# 325 MAIN STREET PUBLIC REALM

CRA Design Review Package  
January 29, 2020

# BUILDING APERTURE FRIT REMOVAL

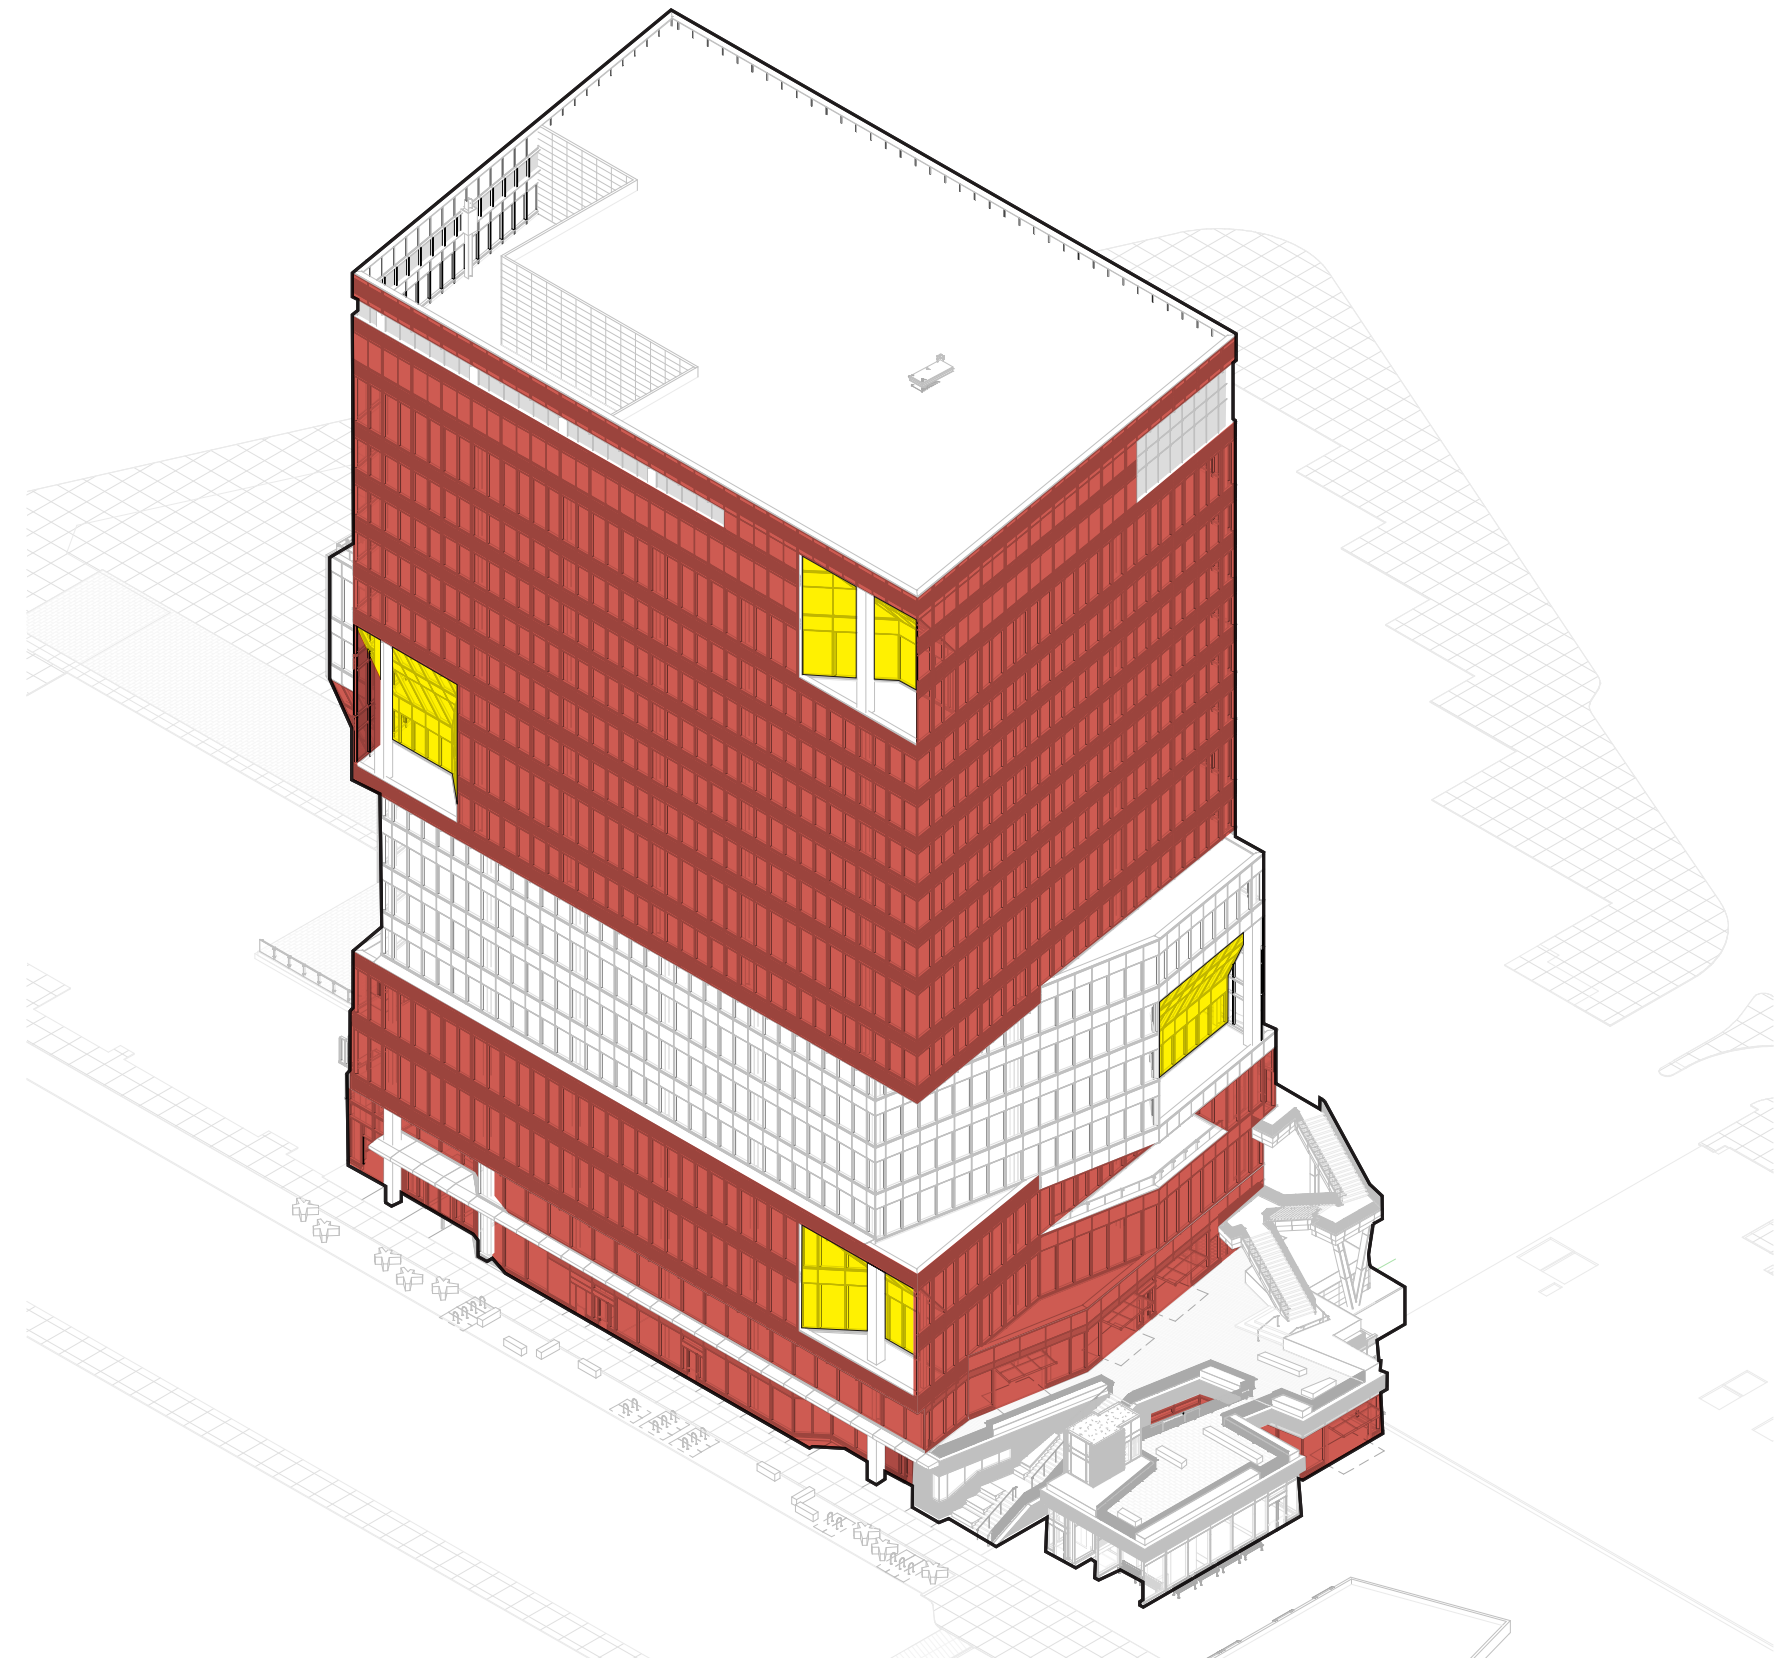
-CONCERNS OF INTERIOR SPACE QUALITY IN REGARDS TO SHADOWS AND VISIBILITY THROUGH THE FRIT ON SLOPED GLAZING.

-REMOVAL OF FRIT FROM ALL SLOPED VISION GLAZING IN THE PROJECT WILL ALLOW FOR A MORE CONSISTENT USER EXPERIENCE.

-THE CARVED APERTURES CREATE A SMOOTH FACADE SUBTRACTED FROM THE OVERALL TEXTURED FACADE. THIS REVISED APERTURE STRATEGY WILL YIELD SMOOTH, GLASSY, AND UNINHIBITED VISION ZONES.

# PUBLIC REALM HANDRAIL REVISIONS

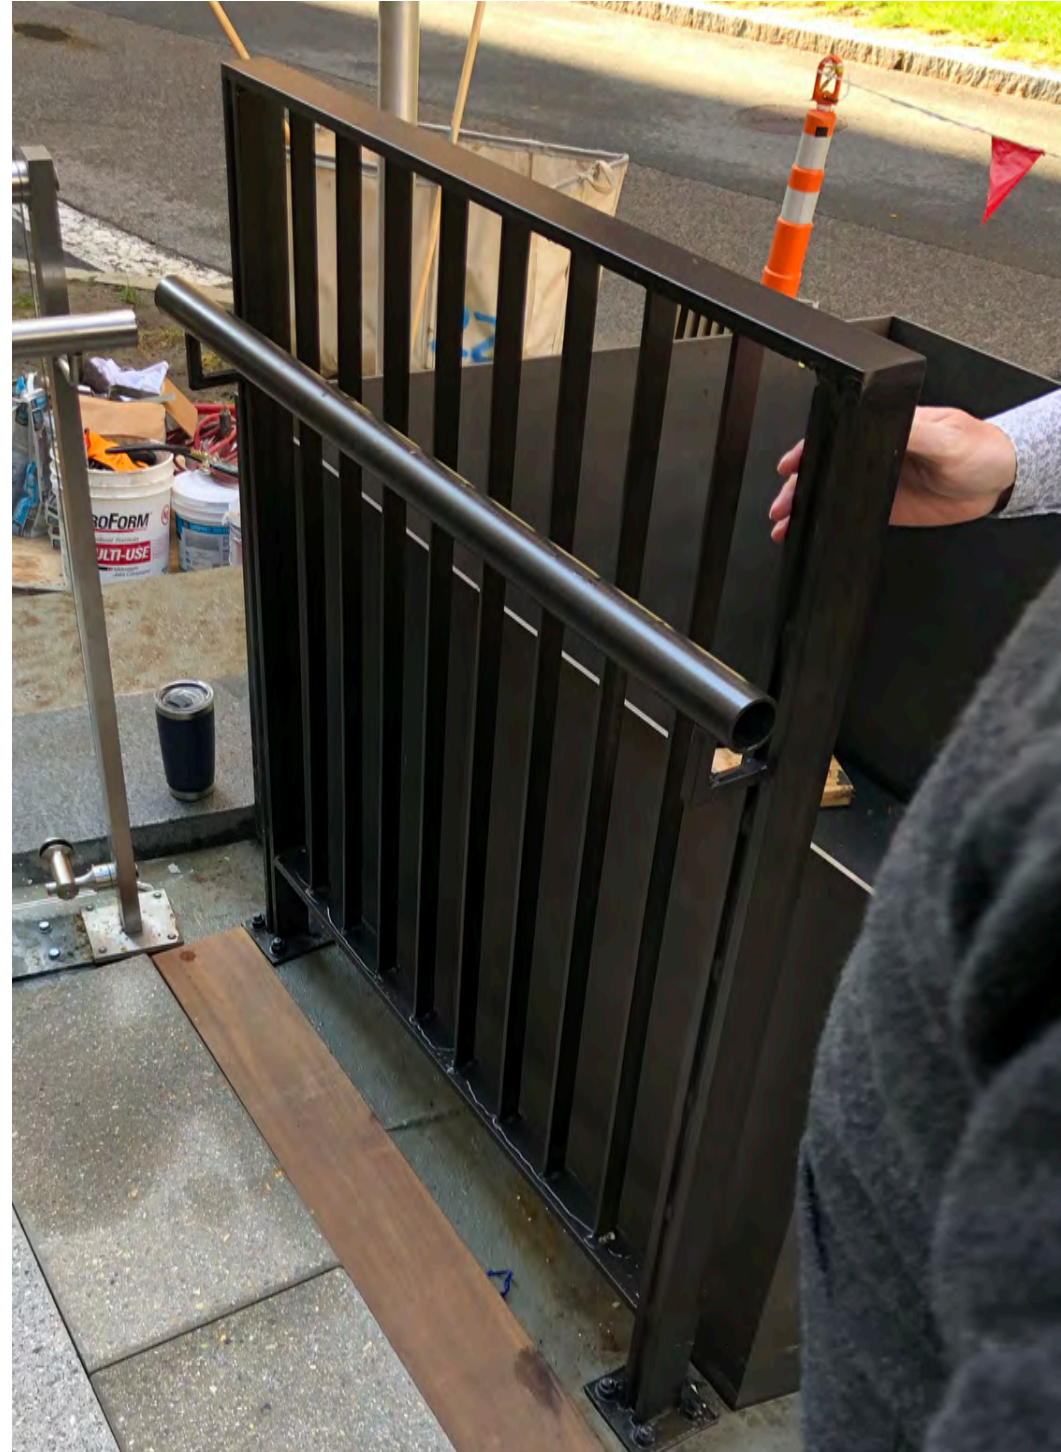
VMU AND DESIGN FEEDBACK - CRA/CDD COMMENTS:

1. CAN THE DESIGN INCORPORATE MORE HORIZONTAL ELEMENTS? IF NOT, WHAT ARE THE REASONS THIS CANNOT BE ACHIEVED IN THE DESIGN?
2. WOULD IT BE POSSIBLE TO INCORPORATE WOOD INTO THE OVERALL DESIGN OF THE RAILING, SPECIFICALLY THE HANDRAIL?
3. WHAT CAN BE DONE TO GIVE THE RAILING A MORE SUBSTANTIAL AND CIVIC FEELING?

# PUBLIC LOBBY VESTIBULE - INCREASED TRANSPARENCY

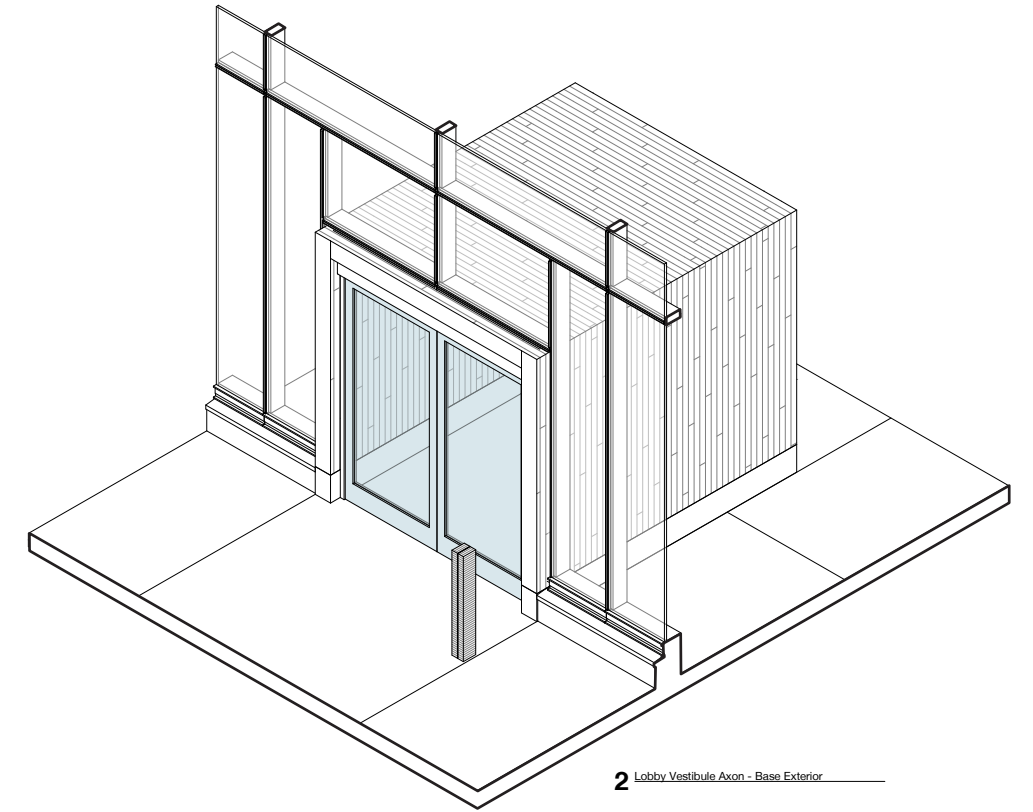
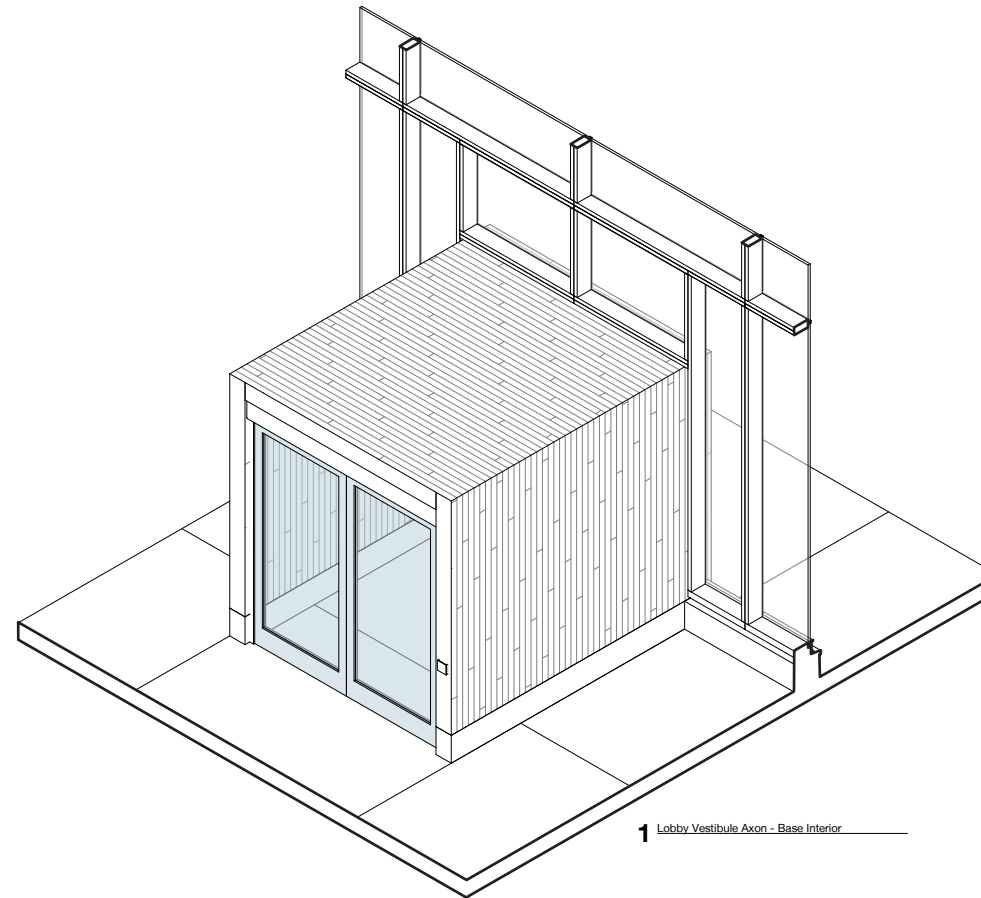
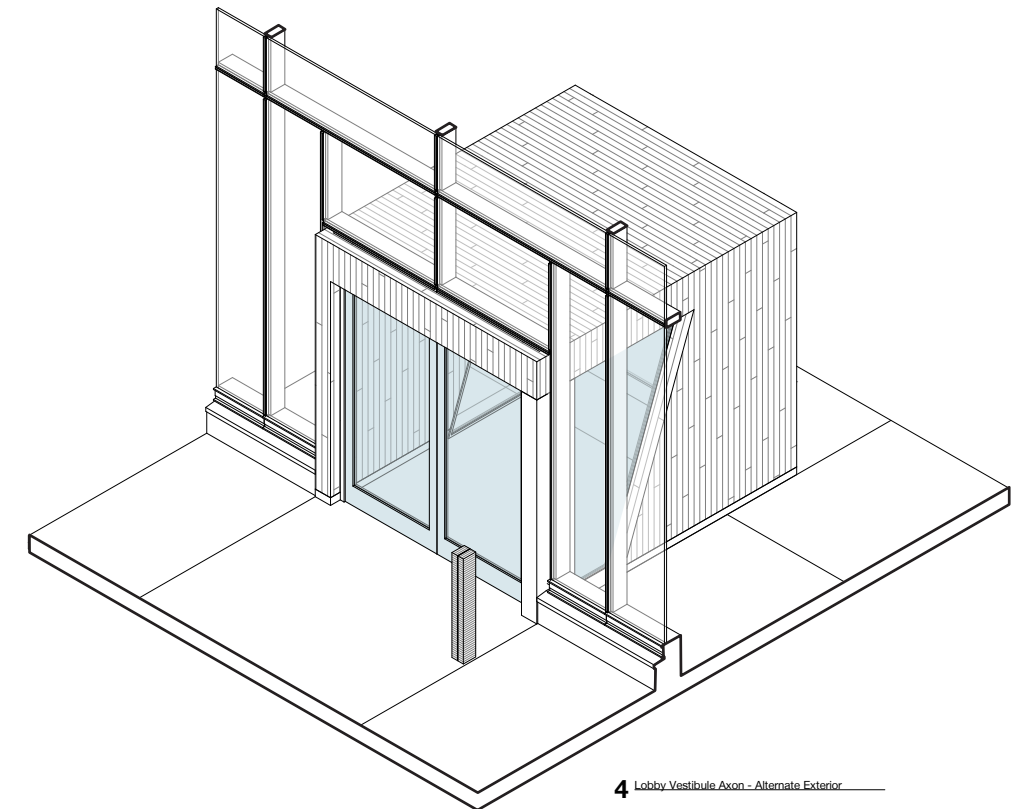
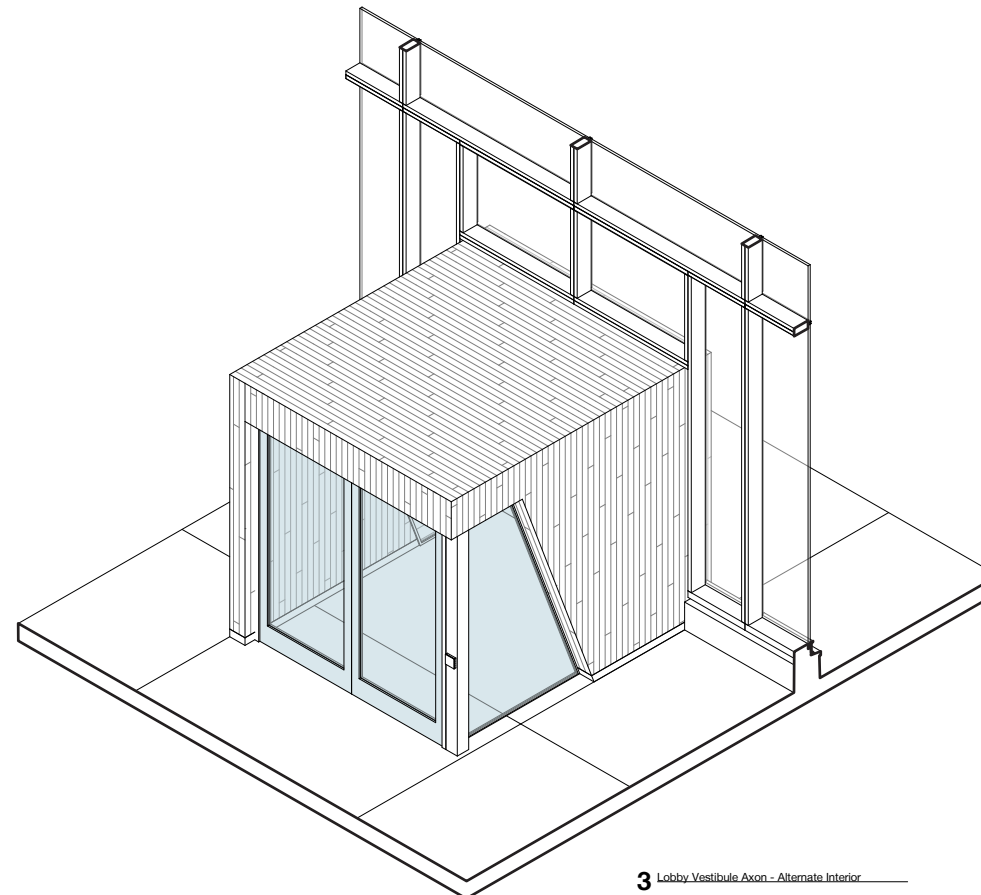
- PUBLIC LOBBY PORTAL ENTRIES TO BE WARM, BRIGHT, AND INVITING.
- VERTICAL STRUCTURAL AND MECHANICAL ELEMENTS REQUIRE PORTIONS OF THE WALLS TO REMAIN OPAQUE.
- THE VESTIBULE CEILING DEPTH AND OPACITY IS REQUIRED FOR MECHANICAL AND ELECTRICAL SUPPLY.

- GLAZING TO BE ADDED TO THE OPPOSITE SIDES OF VESTIBULE FOR CONTINUITY AND TO ENSURE A VISUAL CONNECTION TO MAIN STREET AND THE PUBLIC LOBBY WHILE INSIDE THE VESTIBULE.
- SOLID PORTIONS OF THE WALLS USED FOR PLACEMENT OF STRUCTURAL AND MECHANICAL COMPONENTS.
- FORM REMINISCENT OF APERTURE GEOMETRIES.
